This shop drawing has been reviewed for conformance with the design concept and information given in the Contract Documents.

MEAD LUMBER
Woodside Ridge-Lot 159
Boise Cascade
N/A

File: Woodside Ridge-Lot 159

BC FRAMER

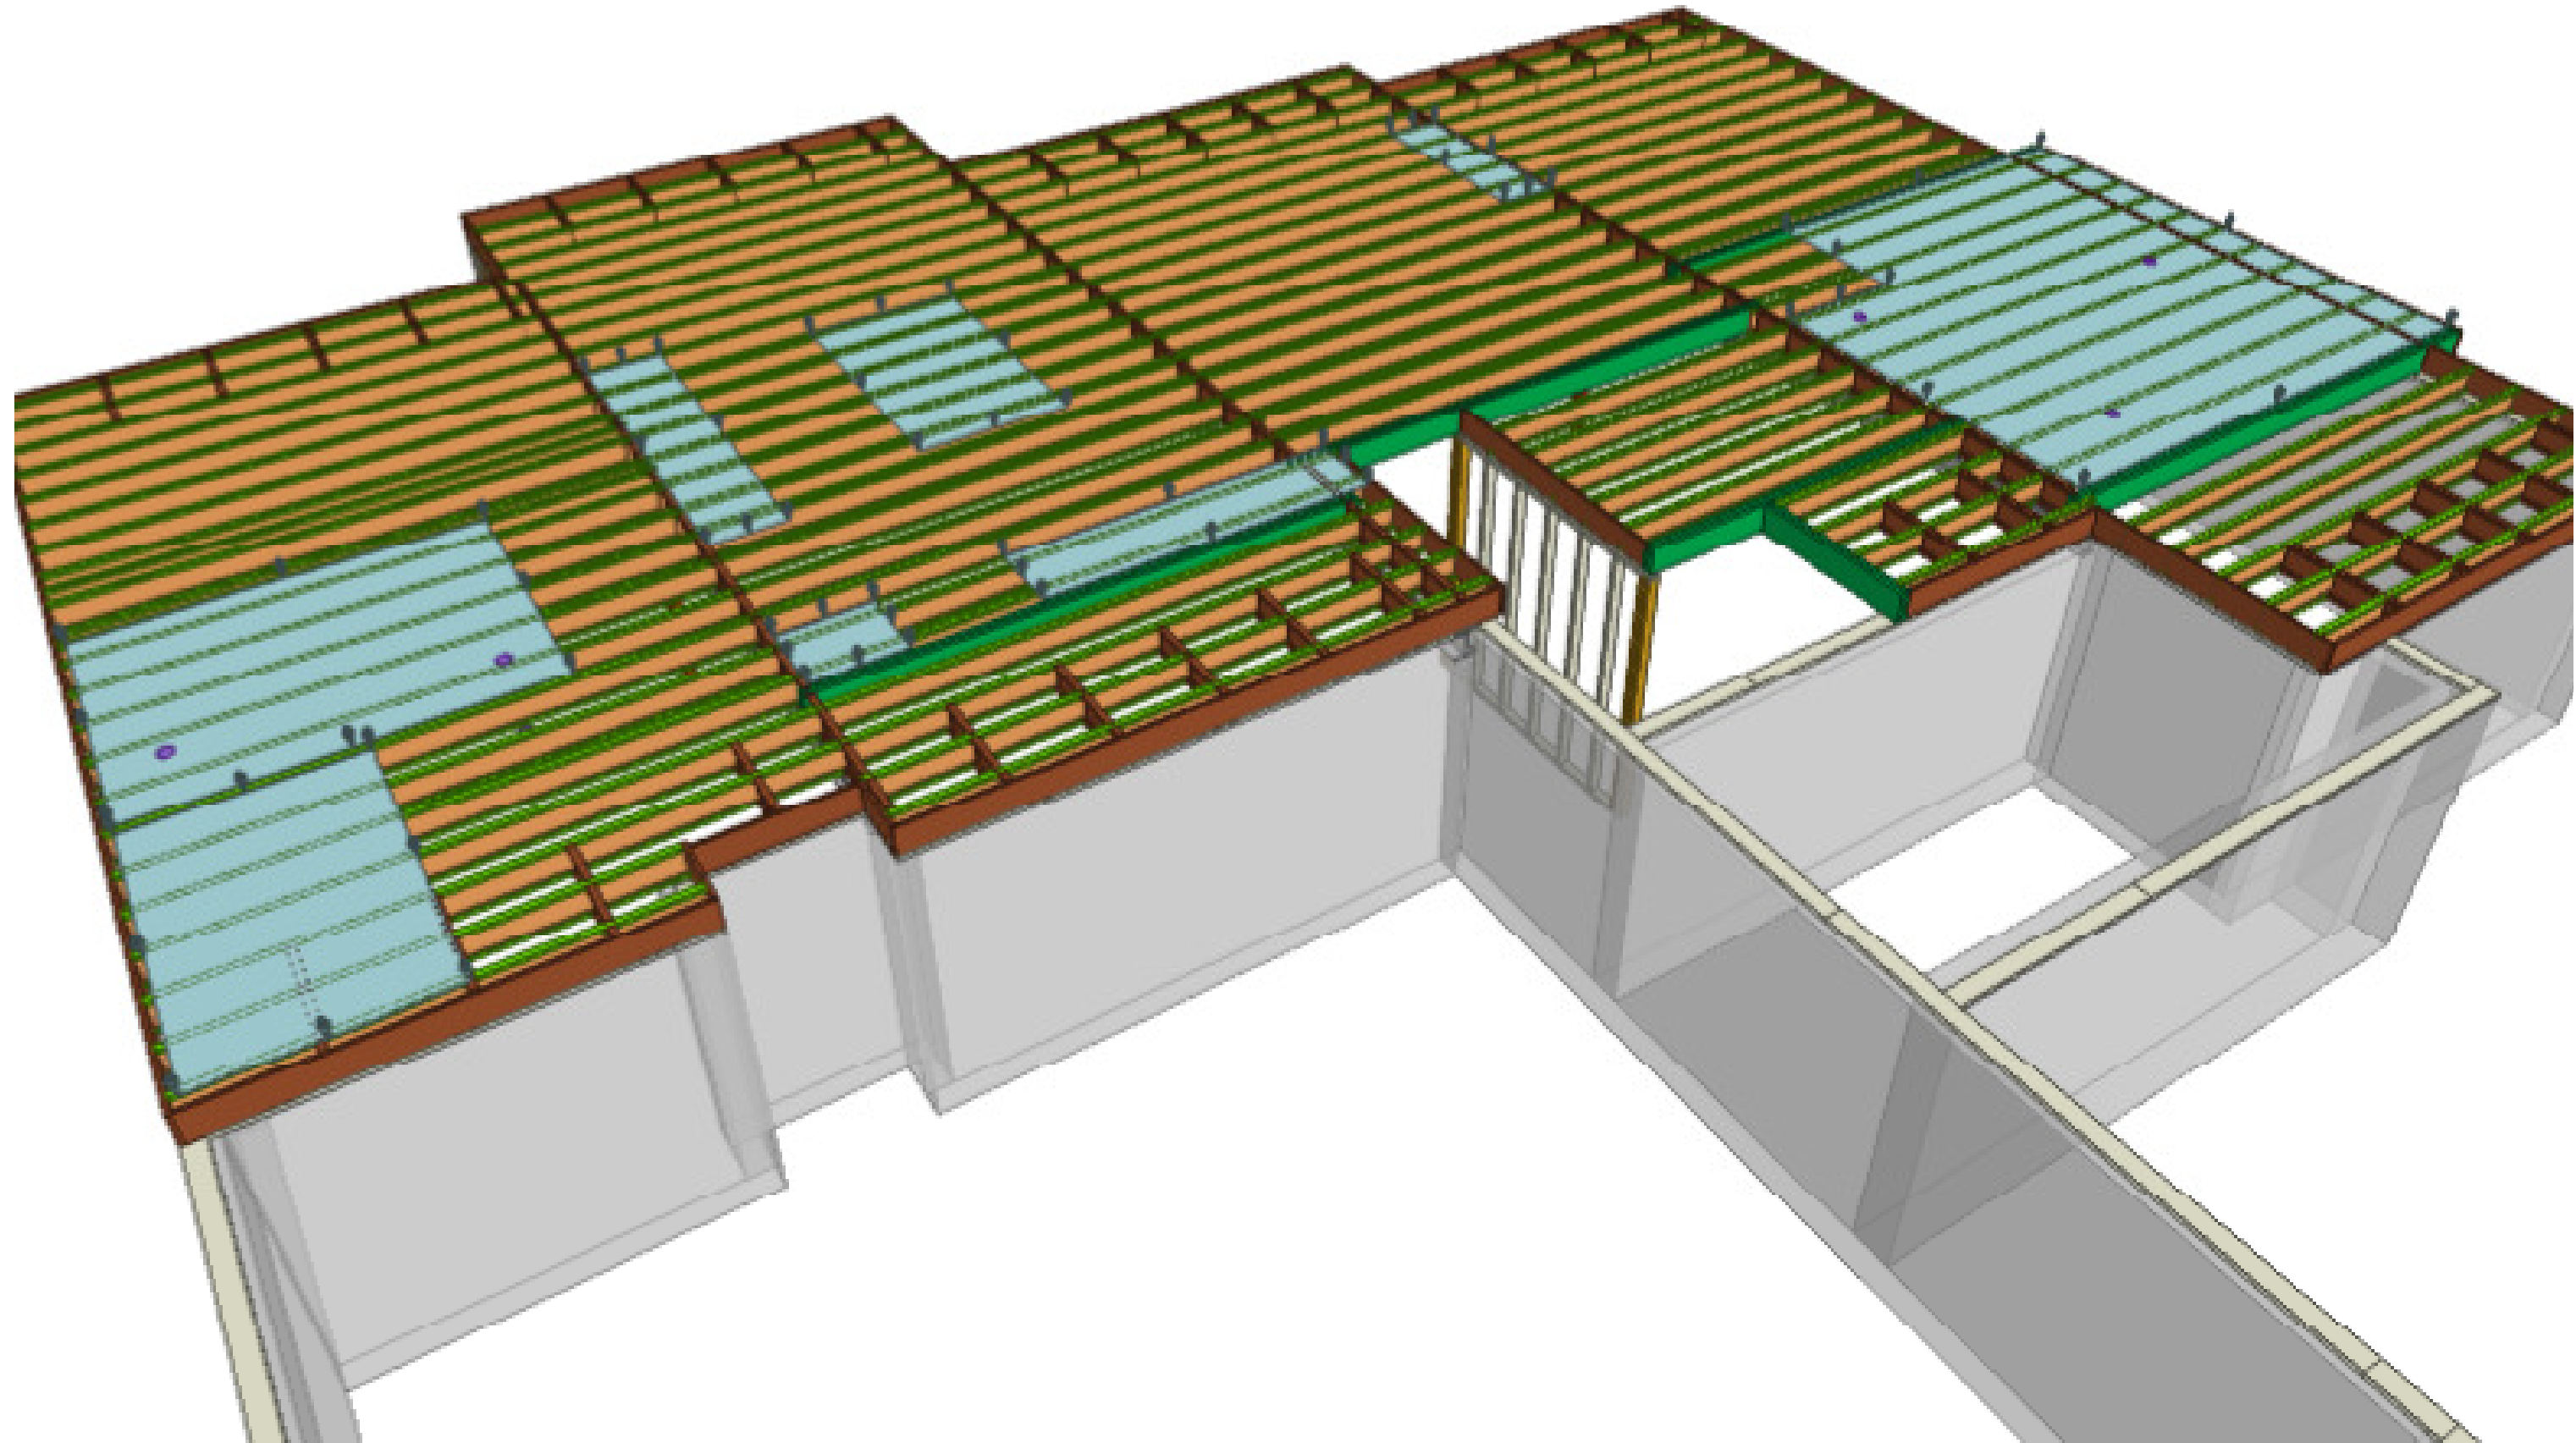
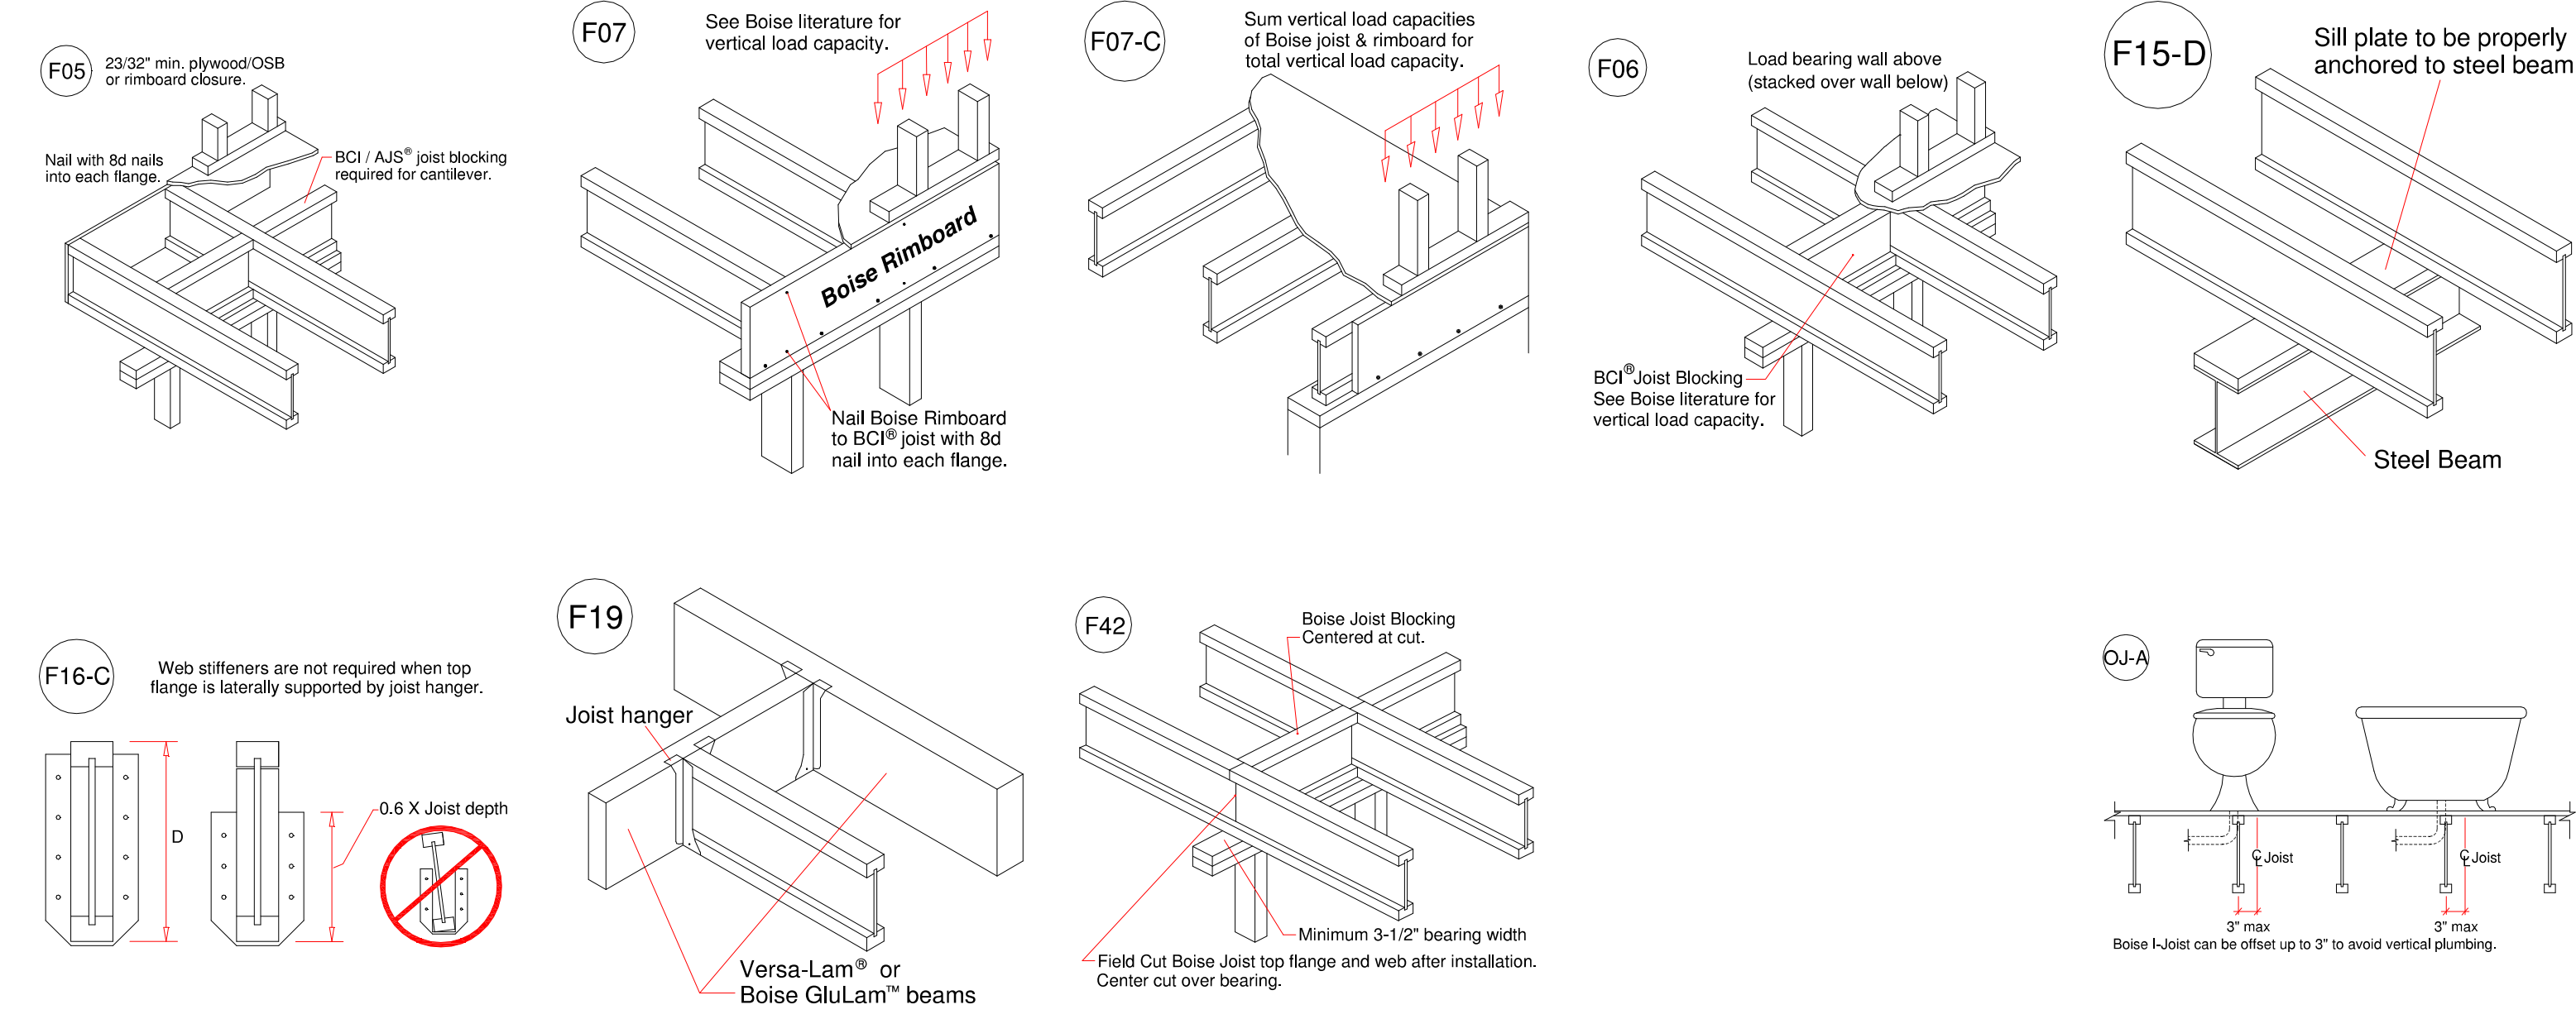
☒ Reviewed with no exceptions noted.
☐ Reviewed as noted.
☐ Returned for correction.
☐ Not Reviewed.
